MEMORANDUM

Subject: **DESIGN RESPONSE CONFERENCE #3**
TOUCHSTONE (PARKPLACE)
FILE DRC09-00002

Design Response Conference Follow-up Items

GATEWAY ENLARGEMENT AT BUILDINGS A AND B

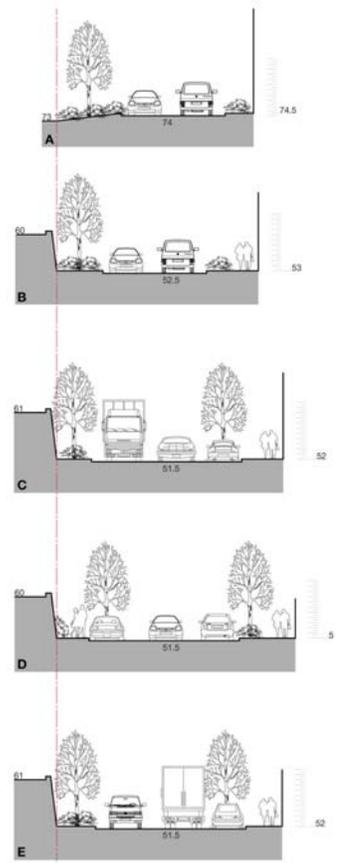
- **Gateway District:** See pages DG-22, 23, and 24 for design guidelines relating to the gateway district at the corner of Central Way and 6th Street. Include step backs along Central Way and be responsive to the context of the surrounding environment and neighboring buildings.

LMN is providing updated design information in response for the 06/29/2009 Design Response Conference

CONCEPTUAL SKETCH OF ATRIUM / BREEZEWAY

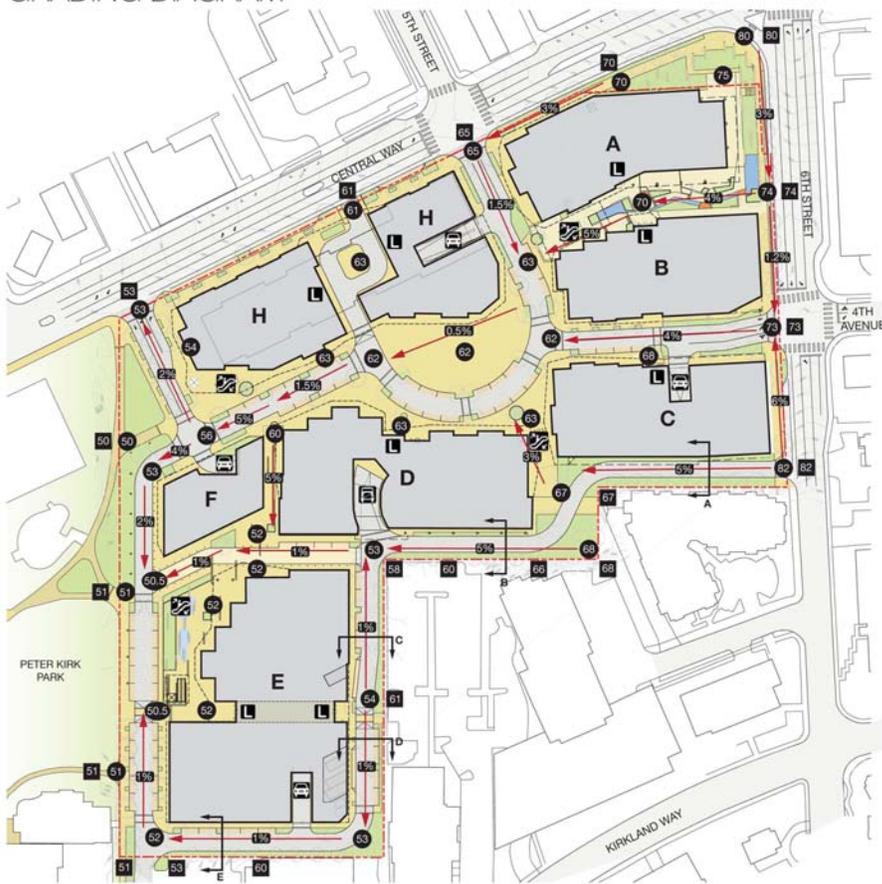
- **Atrium/breezeway area:** Visual openness is needed in the atrium breezeway area...it feels tight. Show how the area includes retail space and invites public use (See page DG-23 of design guidelines for description of this area).

LMN and Hewitt are providing updated design information

6TH STREET ACCESS PER MASTER PLAN AND DESIGN GUIDELINES

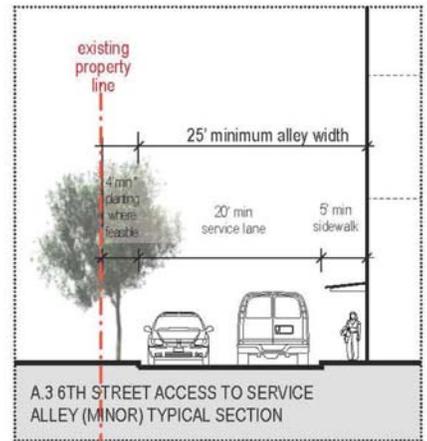
* a landscape or architectural screen should be incorporated along south east property line to buffer property from the adjacent the residential use, (see design guideline on page 27 for exact location).

** an 8' pedestrian path is required along the established pedestrian connections on the southeast portion of the street.
